Subject: Zion Station Units 1 and 2
 Fire Protection
NRC Docket Nos. 50-295 and 50-304

Additional responses to Fire Protection TER open items

ZION FIRE PROTECTION ASSOCIATED CABLE REPORT

FIGURE 1
SATURATION TEMPERATURE (Tcold)
VERSUS
STEAM GENERATOR PRESSURE

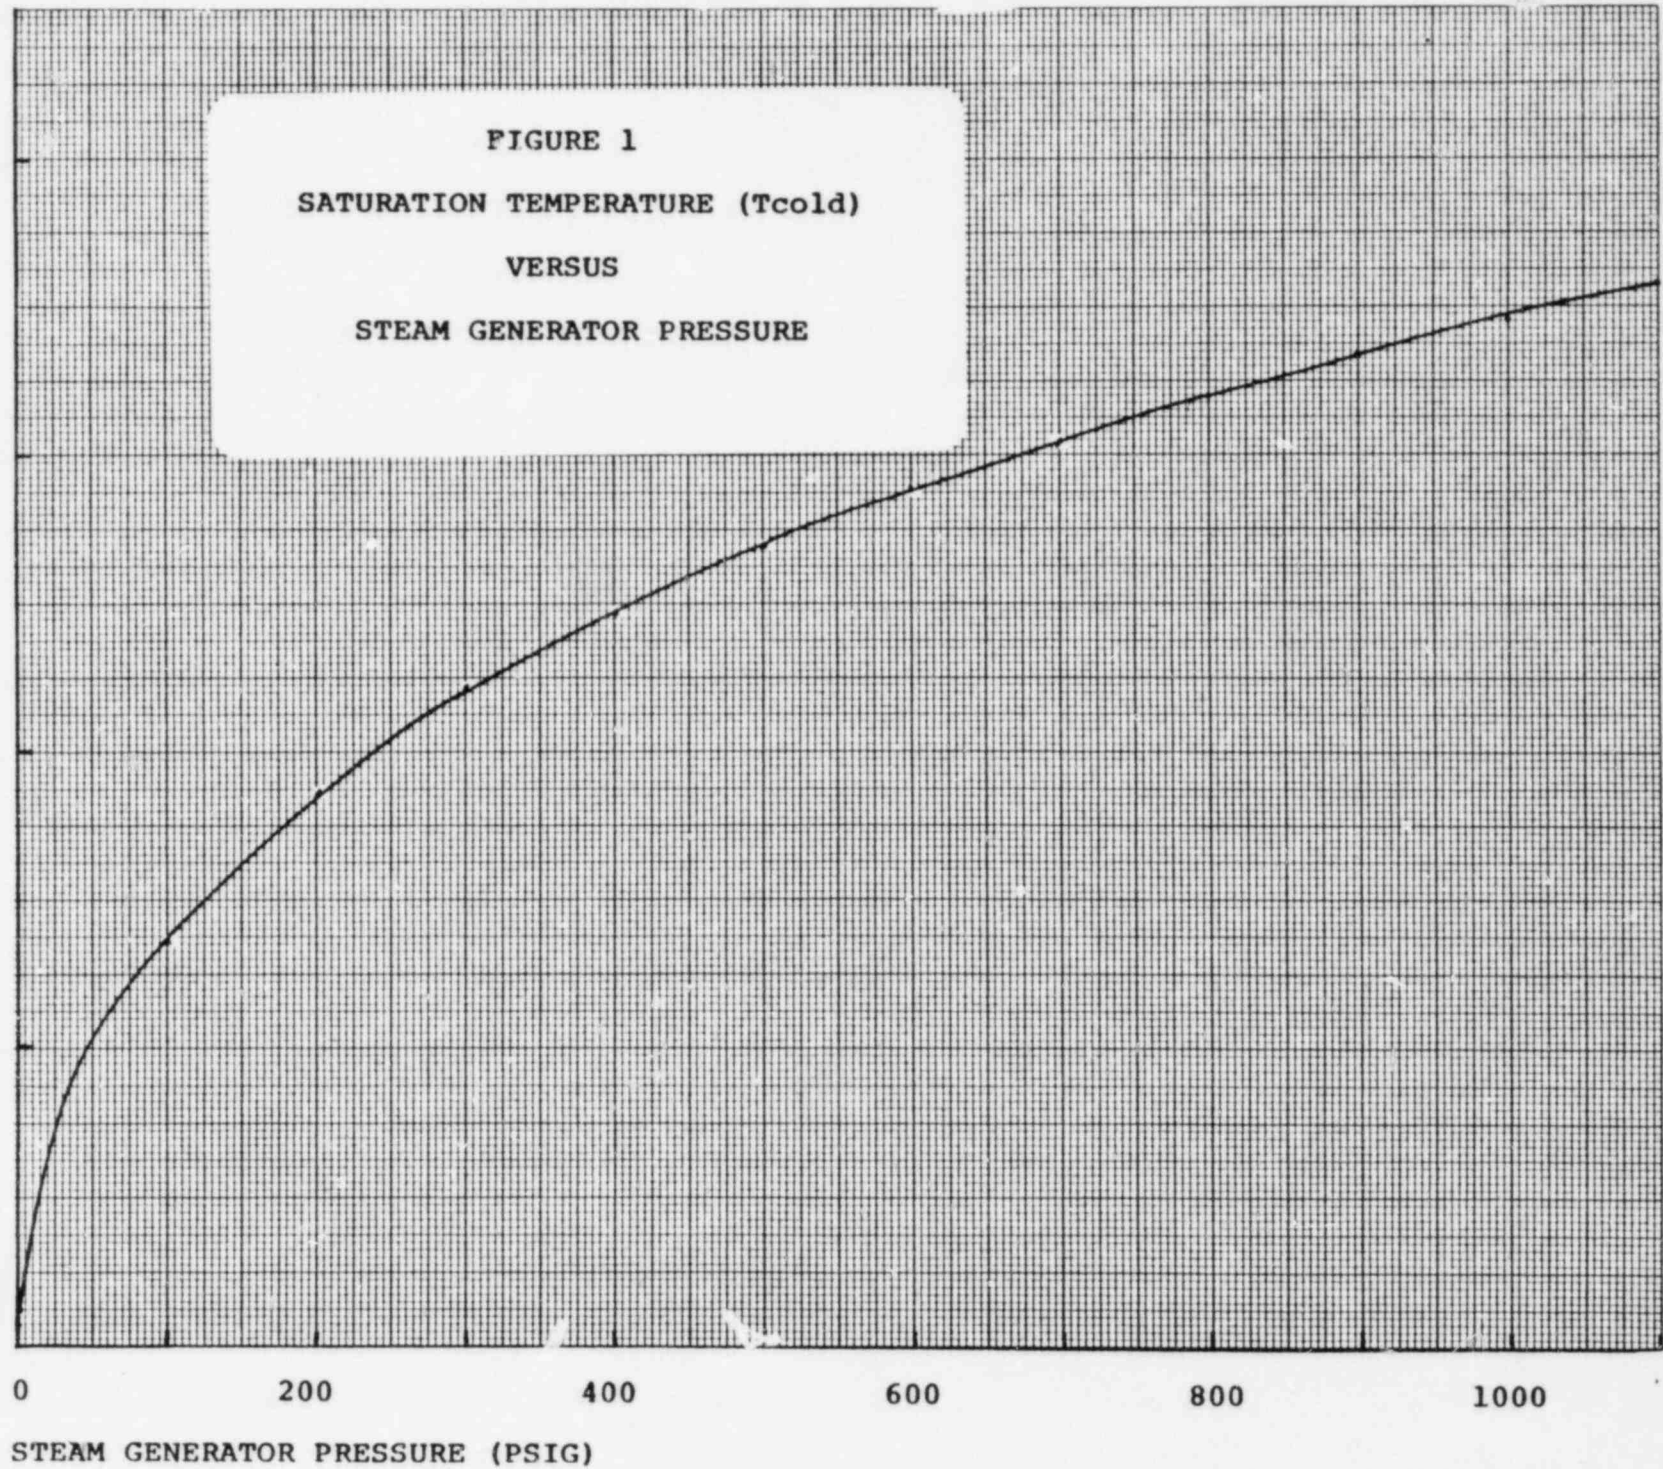
"The licensee has not provided instrumentation to monitor the reactor coolant system cold leg temperature. A direct cold leg temperature reading is necessary."

- (a) Subcooling - Since it is desired to verify that adequate subcooling margin exists in all regions of the reactor coolant system, temperature measurements from the hottest region of the RCS are used for this determination. The preferred method of measurement is provided by a computer average of the ten highest core exit thermocouples. These thermocouples can also be read manually. If the thermocouples are unavailable, the RCS hot leg RTD's are used as the method of next priority.

- (b) Natural circulation - To verify natural circulation, the ΔT across the core must be determined. While the RCS hot and cold leg RTD's could be used for this purpose, the fact that these instruments have a wide range compared to the ΔT of interest and a recorder display of low resolution make them undesirable for this application. The most accurate determination of the core exit temperature is provided by the core exit thermocouples. The most accurate determination of cold leg temperature is provided by the saturation temperature corresponding to steam generator pressure (T_{sat} closely follows cold leg temperature at all but very low steam pressures 30 psig). If core exit thermocouples are unavailable, hot leg RTD's could be used. As described in our July 30, 1982, response, steam generator pressure will always be available, given any fire.

1. Determine T cold from S/G pressure using Figure 1 or steam tables.

SIMPLIFIED SCHEMATIC OF
PRESSURIZER, AUX. SPRAY
SAFETY & RELIEF VALVE SYS.
ZION STATION UNITS 1 & 2
COMMONWEALTH EDISON CO.

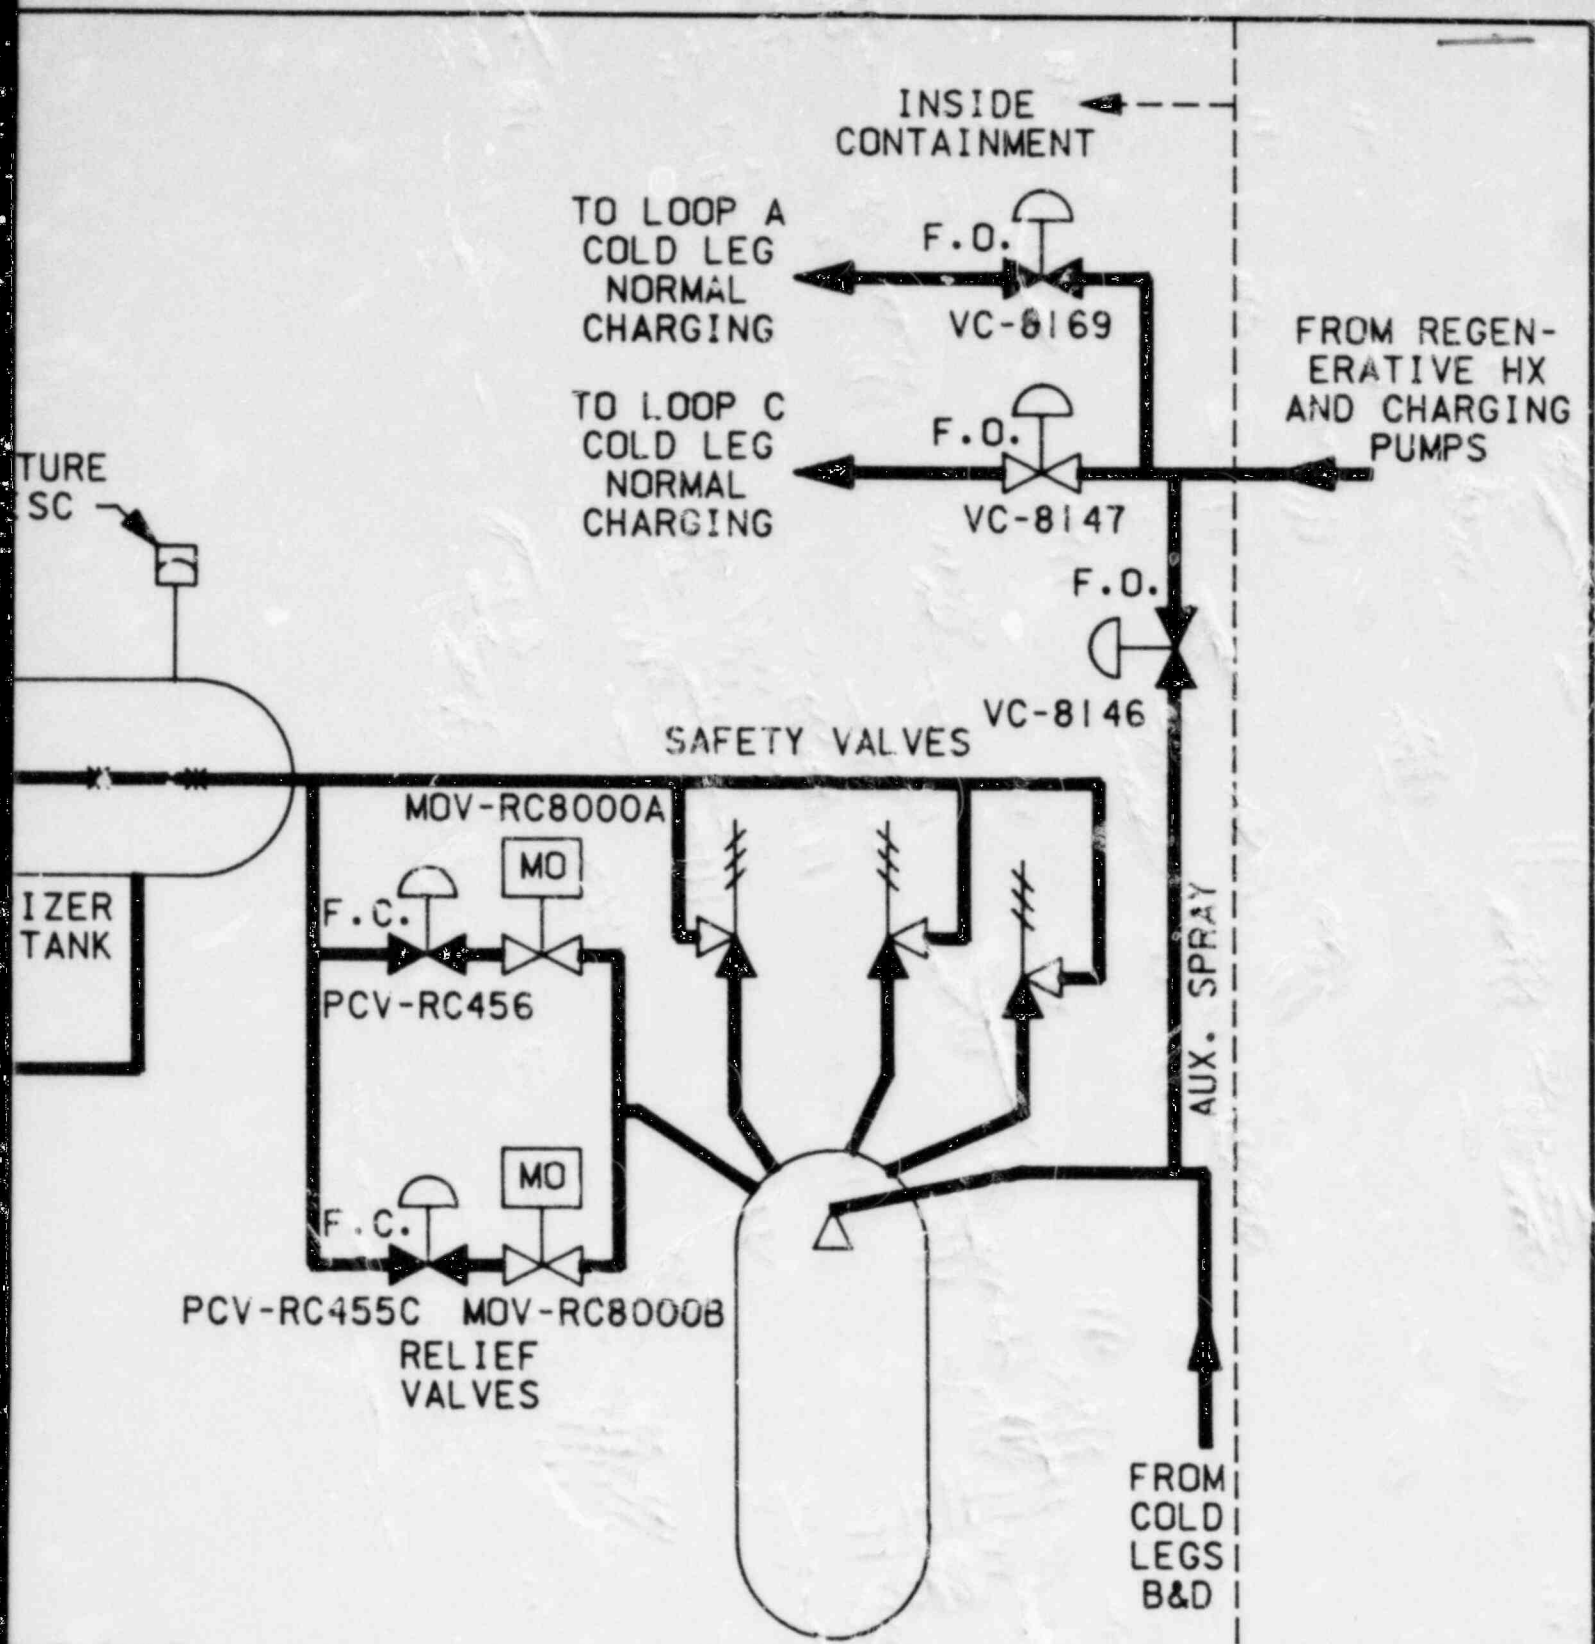
"How will pressure control be maintained with the auxiliary spray, while valve VC-8146 is closed due to the fire, prior to its being manually opened?"

With the unit in hot shutdown, reactor coolant temperature and pressure are maintained at their desired no-load values by control of decay heat removal by the steam generators. As described in our response of April 16, 1982, decay heat removal can be provided by the operation of the steam generator atmospheric relief valves, given any fire. With this method of temperature and pressure control available, the reactor can be maintained in the hot shutdown condition indefinitely.

If it is desired to go to cold shutdown, a method of reducing reactor coolant pressure must be provided. As described in the Zion Safe Cold Shutdown Analysis (May 29, 1980), pressure reduction capability can be provided by the auxiliary spray valve VC-8146, given any fire other than at the valve itself. This valve is an air-operated valve whose ability to be remotely operated could be affected by a fire at the valve. However, after the fire was extinguished, the valve could be manually operated. As described above, the reactor could be maintained in the hot shutdown condition by control of decay heat removal until valve VC-8146 could be operated manually.
